# **ASSESSMENT AND REVIEW OF AESTHETICS AND ORDERLY DEVELOPMENT FOR THE PROPOSED CHELSEA SOLAR PROJECT - Case No. 17-5024-PET**

Bennington, Vermont

June 19, 2018

Vermont Public Service Department  
112 State Street  
Montpelier, VT 05602

**FIGURE 1. Context Map**

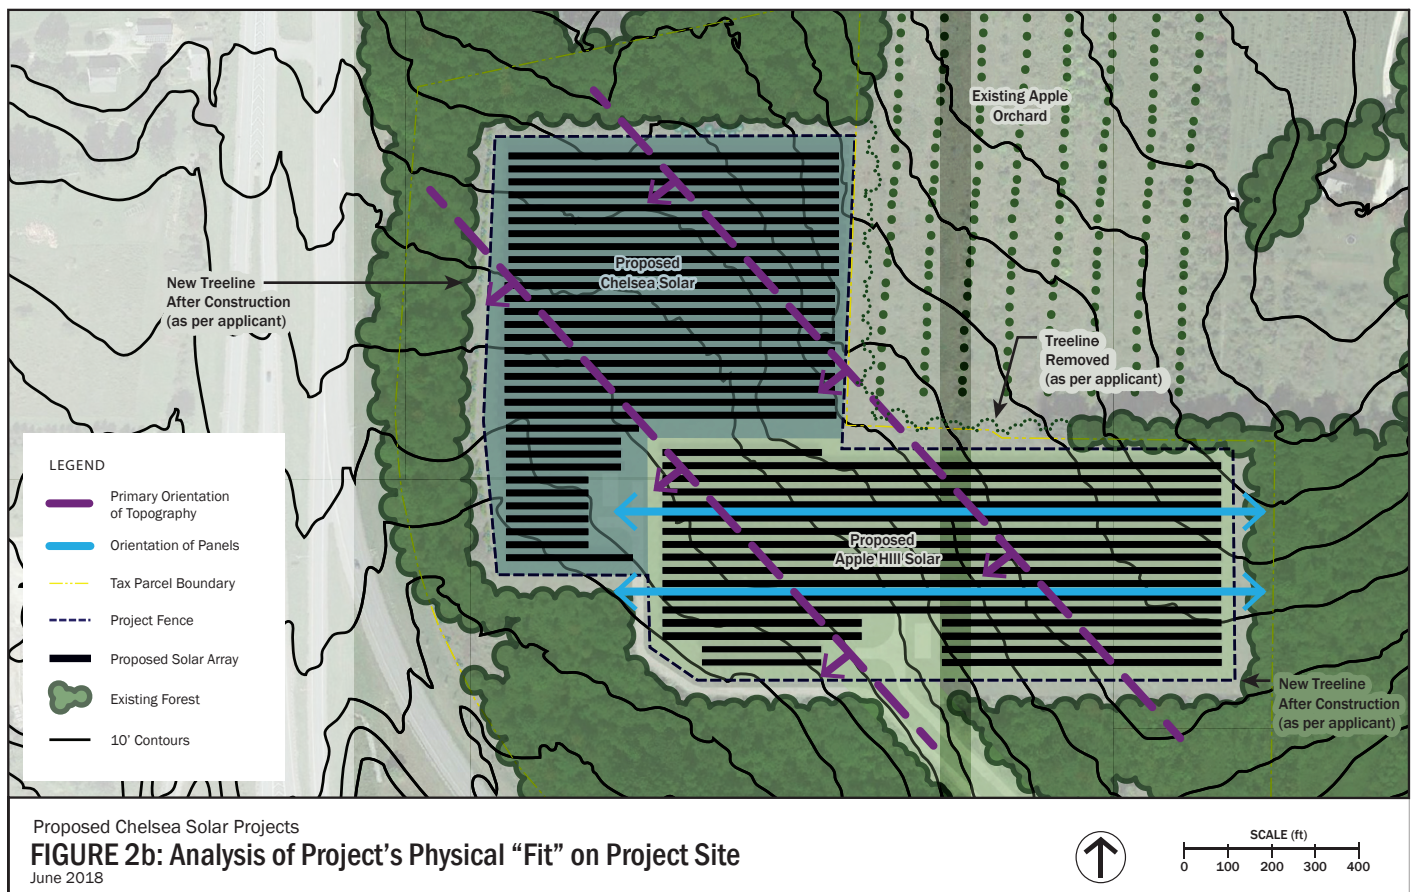
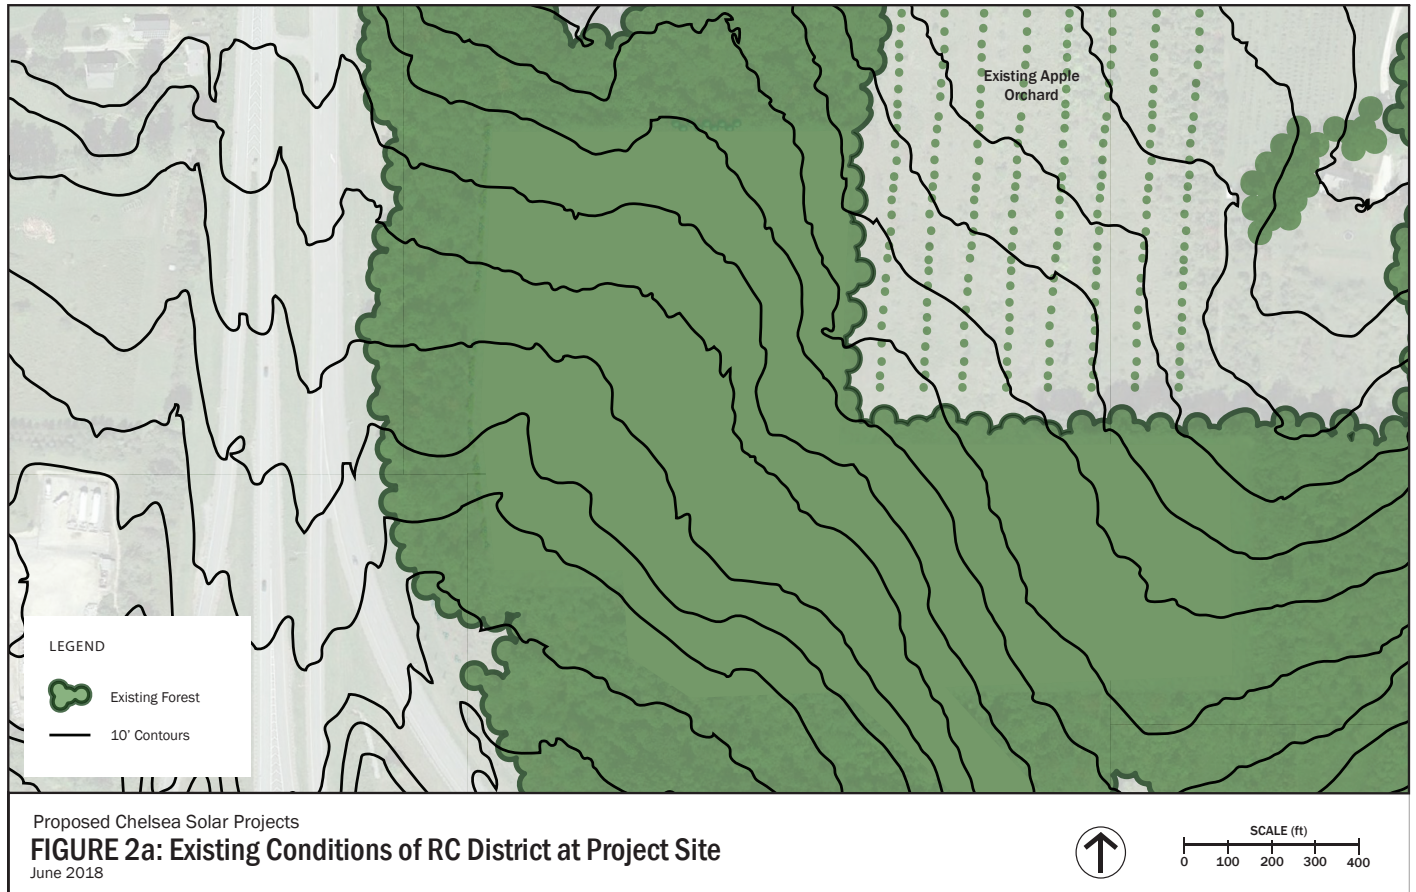
The size and scale of the Chelsea Project is compatible with its surroundings on a regional scale in so far as this is a transitional area between a multitude of differing uses and districts (see Figure 1. Context Map). It is bounded on the south and west by US Route 7 and the VT 279 interchange, the Vermont Welcome Center, and mixed residential, commercial and industrial beyond. It is a busy, high-density area with lots of traffic, commerce, and day-to-day activity. There will be very limited visibility of the Project from these areas, and not likely noticeable given the activities that occur here. While there might be minimal visibility from the Welcome Center or the roadway, the Project is sufficiently separated by topography and existing vegetation and would not be incompatible with the development patterns that are already present and visible here. To that end, the Project fits within the context of these surroundings.

To the north and east of the Project, however, the area is best described as residential and rural residential. The Project parcel is at the cusp of these two very different landscapes and the forested area provides an important buffer between the two contrasting settings. The overall perception of the area as viewed from here is completely different – it is a more quiet, rural, limited density, and arguably scenic setting. The Town Plan further confirms this assessment, describing the Rural Conservation District as valley areas “that have retained their rural and open space character.” (2015 Town Plan pg. 28) Even though they are only several hundred feet away, the highway and commercial areas are not visible or noticeable, giving the surroundings a more bucolic and pastoral feel. These areas are completely disconnected from the south and west insofar as access is not possible from the highway, so the approach provides a different context and aesthetic appeal as well. Given the nature of the adjacent development patterns, visible or perceived, and the visual buffering and separation from the contrasting land uses to the south and east, a Project of this size and scale is not entirely compatible with its surroundings or the expectations for this area. The change in character and the extensive loss of an existing forestland will potentially be offensive to those who live here and will experience this change daily (see Figures 2a, 2b and 3). While the Project will be low in height and not occupy a wide panorama view, it introduces a new and foreign element in the landscape that is not commonly seen or expected and would require specific and effective mitigation measures to guarantee it will not dominate or diminish the setting, and to ensure that the perceived value and visual quality of the area is not reprehensibly damaged. To that end, the Project’s design as currently proposed would be adverse.
